Appendix A: DRAFT SEIS COMMENT LETTERS

RE: City of Sumner 2013 Comprehensive Plan Annual Amendments, Sumner Meadows Docket, Draft Supplemental Environmental Impact Statement

Specific Comments to the Sumner 2013 Comp Plan Amendments SDEIS

Attachment B

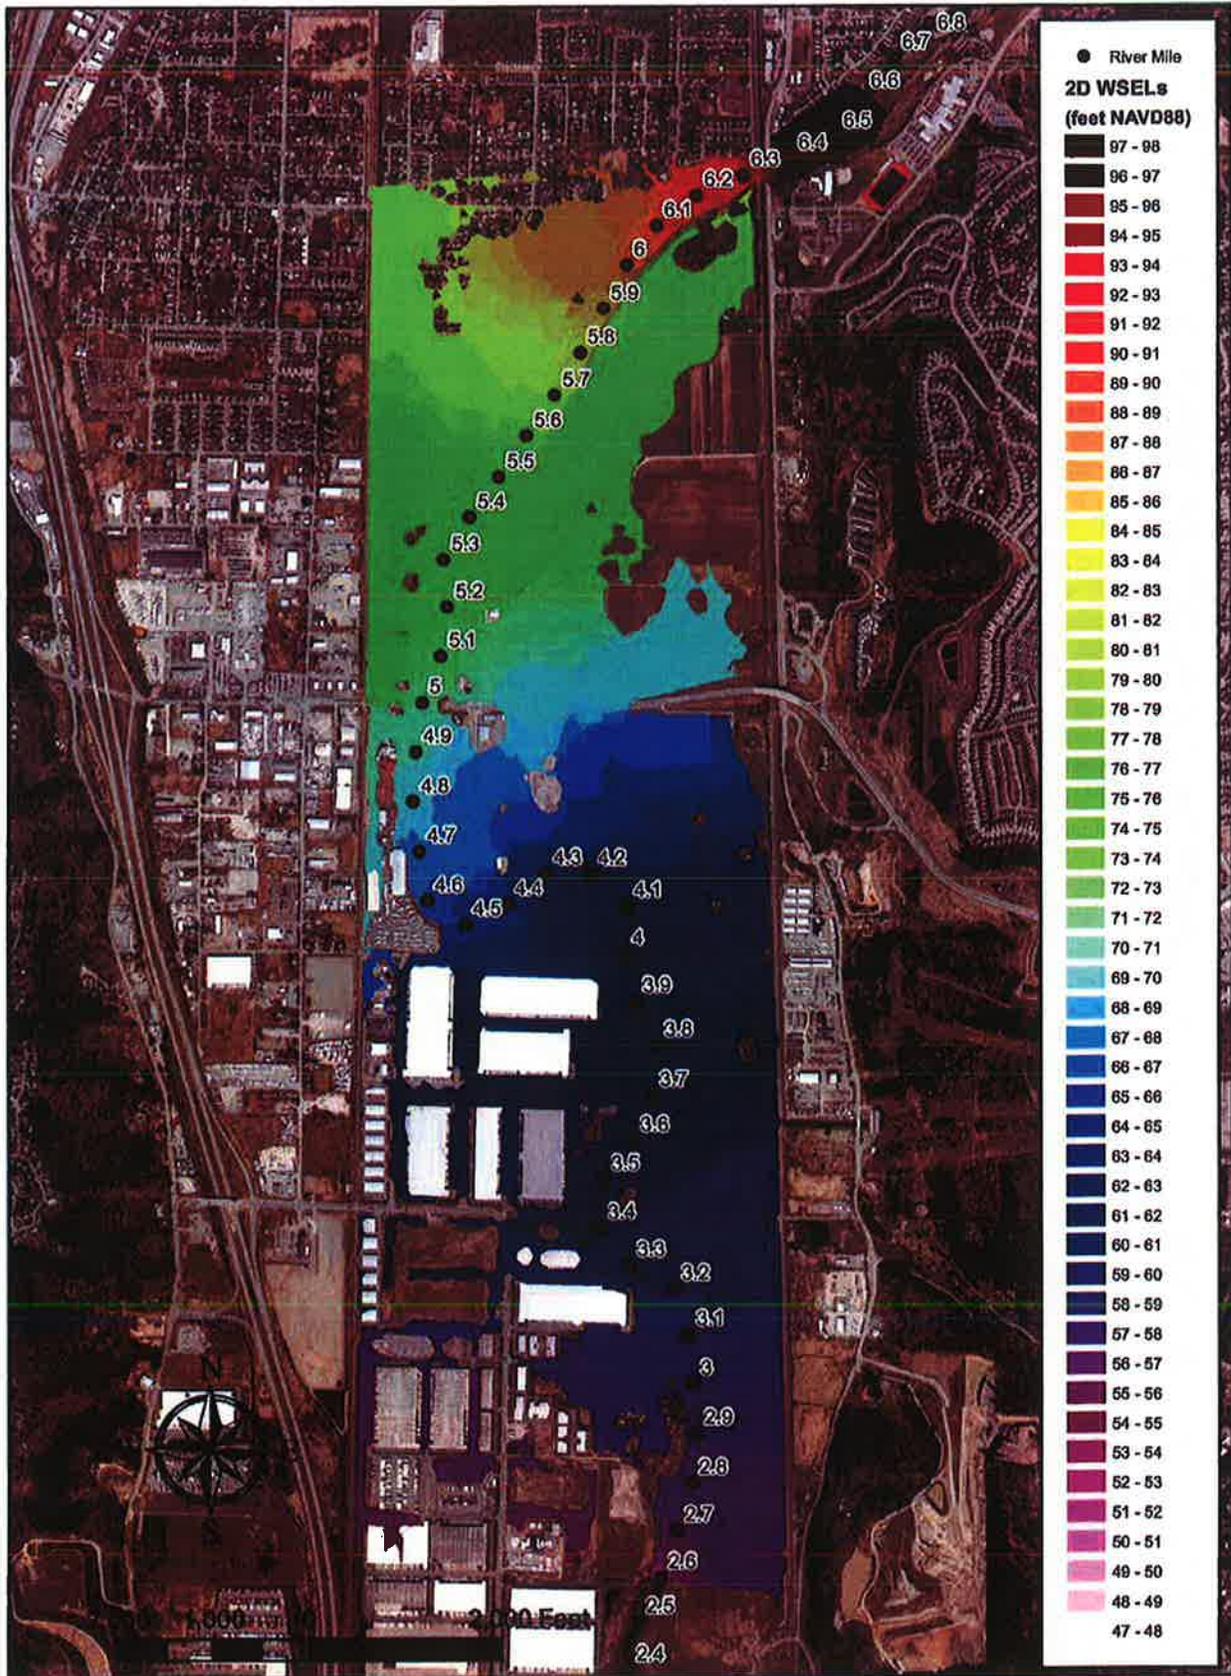
Right bank below 24th Avenue, RM 3.4 – 2.5: The County's 2D model shows complex (but shallow) flow patterns around the existing warehouses (Attachments B and C). This flow trends to the south-southwest away from the river. The 1D model results (Attachment D) shows a constant water surface elevation that is along the entirety of a single cross-section extending from the Union Pacific Railroad at 24th Street, southeast to the left bank floodplain at the BNSF Railway (east of RM 2.5). Consequently, the 1D model results show water surface elevations that are as much as one foot higher and as much as five feet lower than the elevations in the 2D model (Attachment E). The 1D model should include a flow path from the meander bend between RM 3.2 and 3.5 that passes through the right bank floodplain. The water surface contours generated from the County's 2D model can be used to orient the 1D cross-sections through this reach.

Attachment E

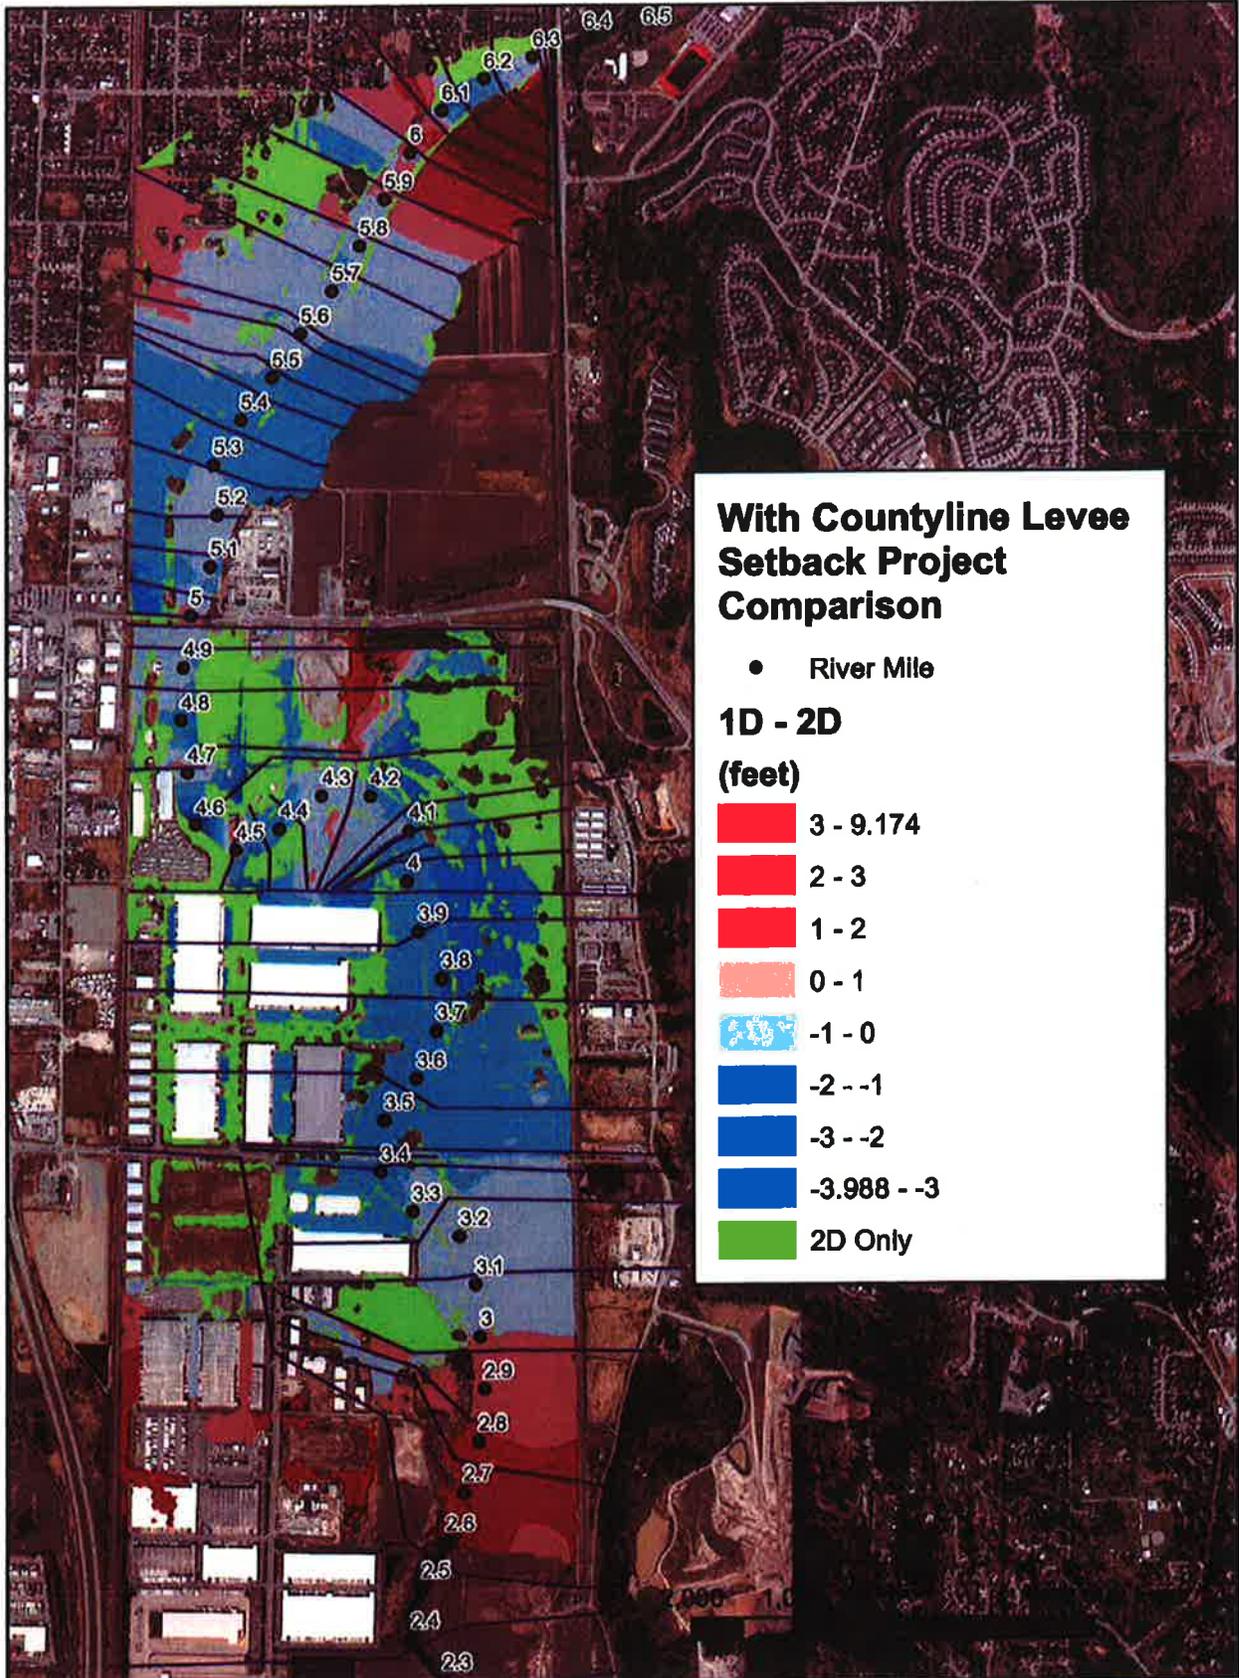
elevations that are one to two feet too low (Attachment E), should be revised to include a split flow path at Government Canal that feeds back to the river at a cross-section located upstream of 8th Street near RM 5.0.

Figure: 14

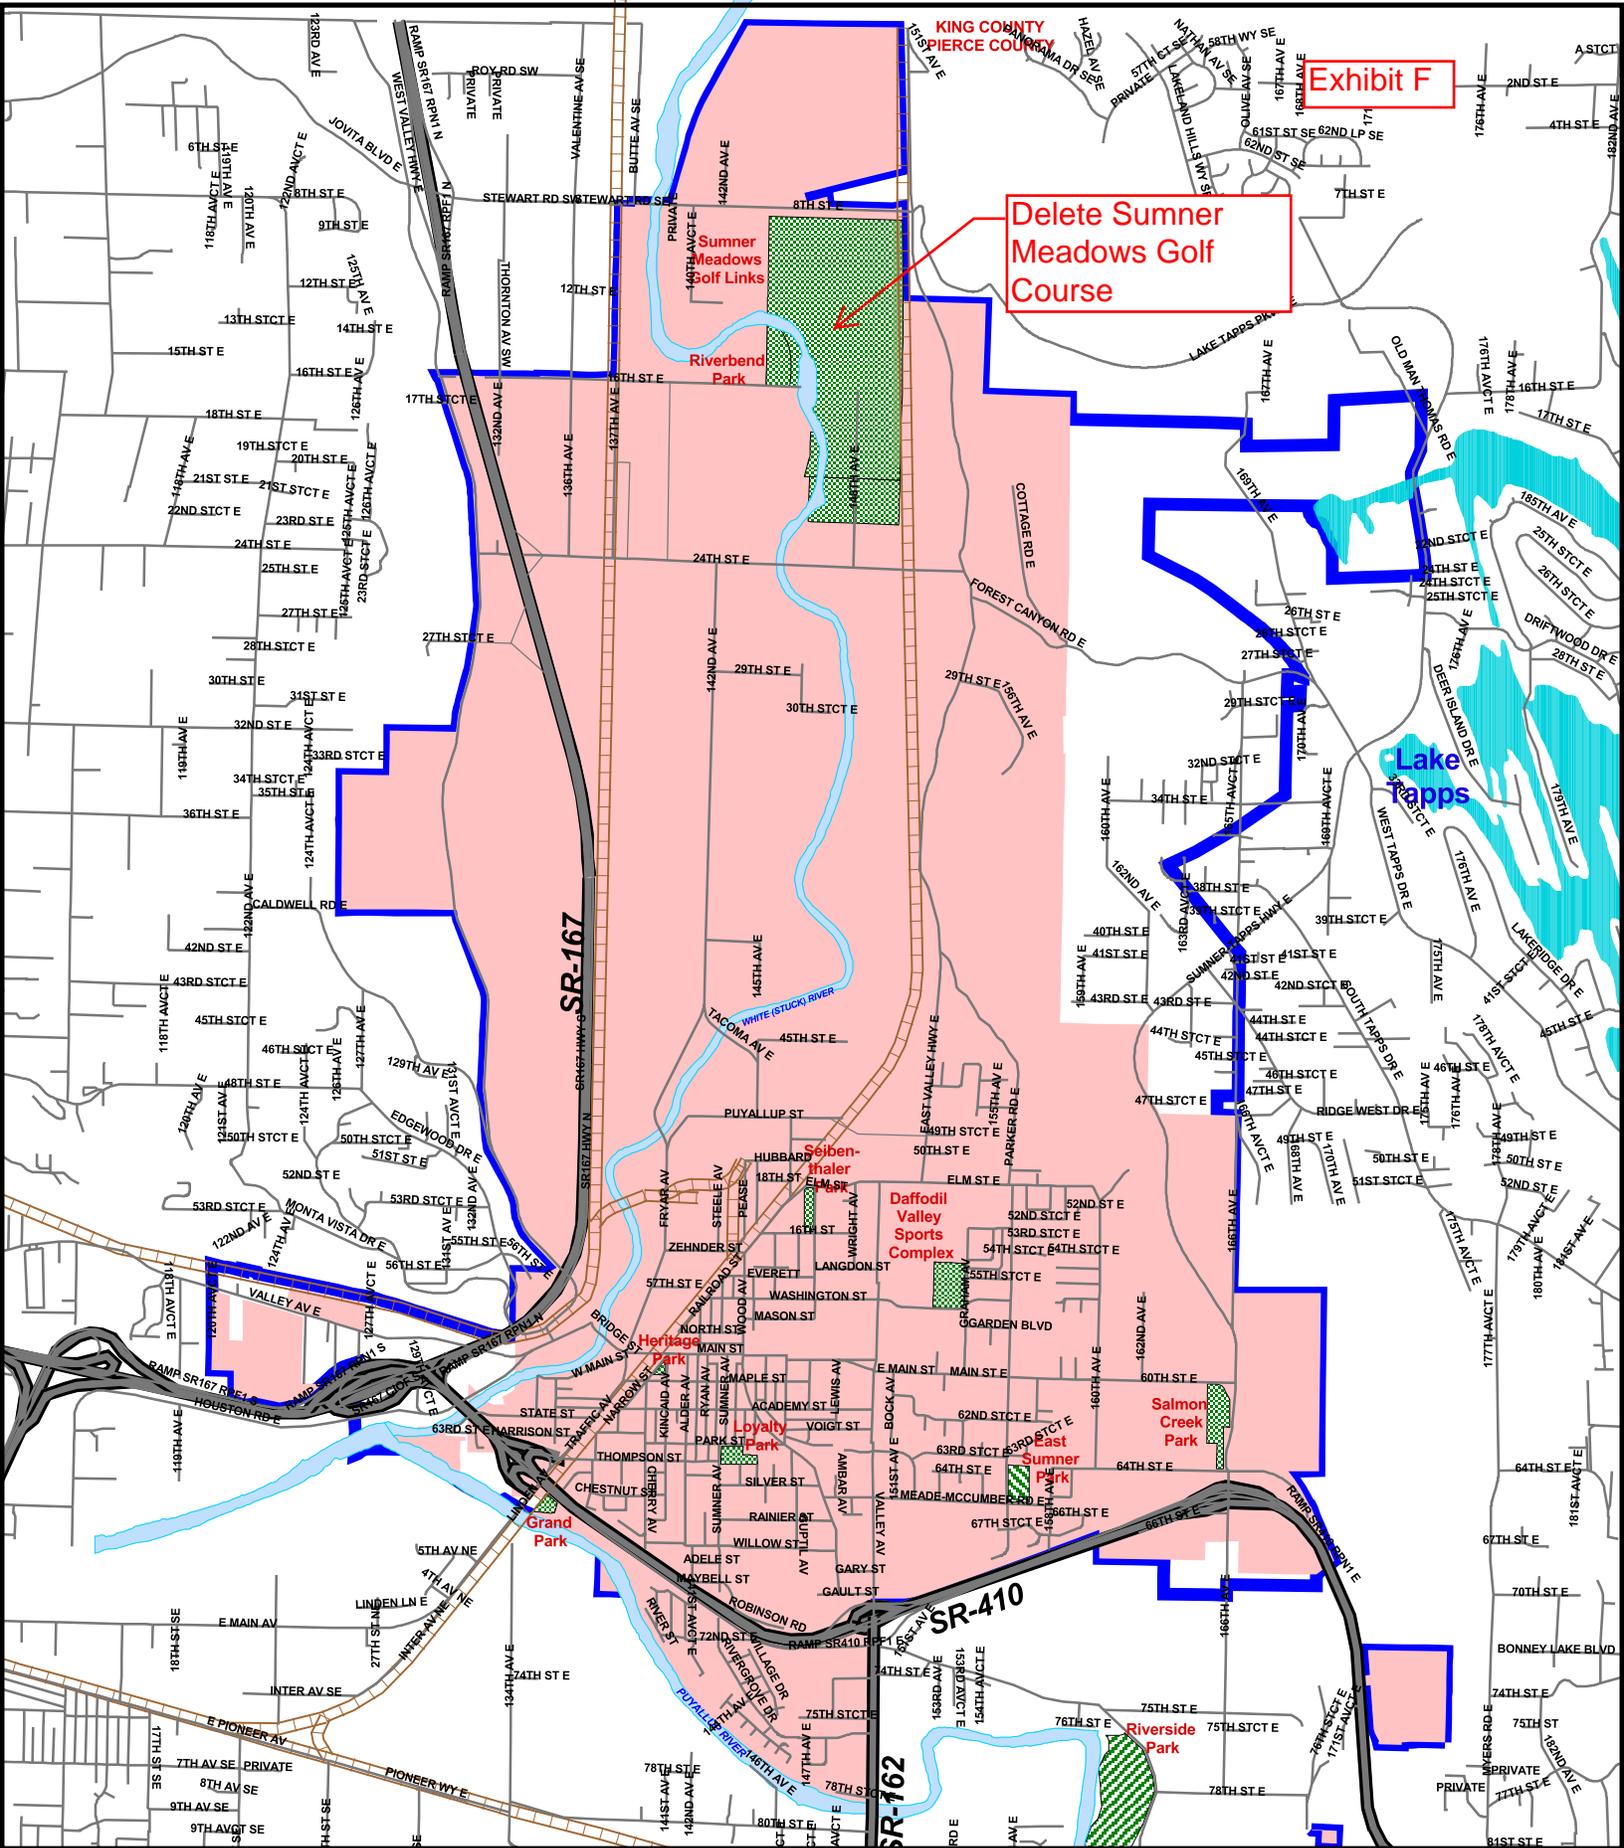
Delete Summer Meadows Golf Course
